Serial No.: 10/718,507

For: CONSTRAINED-ENVELOPE DIGITAL-COMMUNICATIONS
TRANSMISSION SYSTEM AND METHOD THEREFOR

INVENTOR'S SUBMISSION UNDER 37 C.F.R. 1.56

Figure 1. Need for signal delay to follow May's teaching

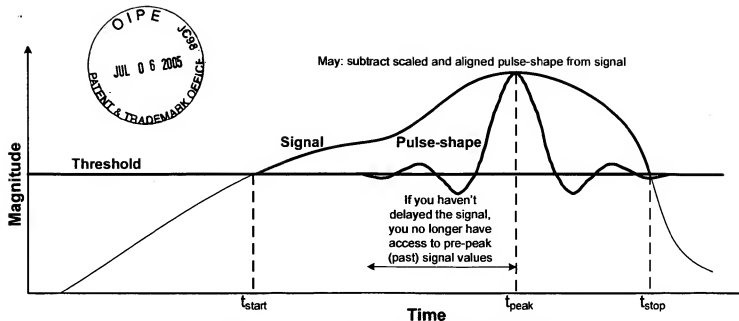
The May paper teaches that you must identify the instant in time in which a signal peak occurs, and then subtract a scaled version of a fixed pulse-shape from the input signal, where the peaks of the pulse-shape and the signal have been time-aligned². Since the pulse-shape extends in both directions in time from the point at which its peak occurs, the teaching clearly requires that the input signal is delayed by at least half of the pulse-shape duration. In view of the foregoing, it is clear that May's approach inherently uses a delay; in my opinion it cannot be done any other way.

The following Figure 1 graphically depicts the necessity for signal delay in implementing May's teaching.

Figure 1 shows signal magnitude over a time interval. At time t_{start} the signal magnitude exceeds the defined threshold, and this condition persists until the signal magnitude once again drops below that threshold at time t_{stop} . The signal magnitude exhibits a peak at time, t_{peak} . May clearly teaches that the scaled bandlimited pulse-shape must be time aligned so that the pulse peak and the signal peak are time-coincident³, the scaling defined so that the magnitude of the difference between the signal and the pulse equals the threshold at that peak instant⁴. May then clearly instructs that the scaled and aligned pulse values must be subtracted⁵ from the corresponding signal values. It is impossible to follow May's teaching without the use of signal delay. In order to subtract pulse values from signal values, all required signal values must be accessible. However, at that point in time (t_{peak}) when this subtraction action is prescribed, all the signal values in the past (left of the peak instant) have already occurred. To follow May's specific instructions to subtract pulse values from *all* (to both sides of the peak instant) corresponding signal values, delay must be used to make sure that past signal values are still available.
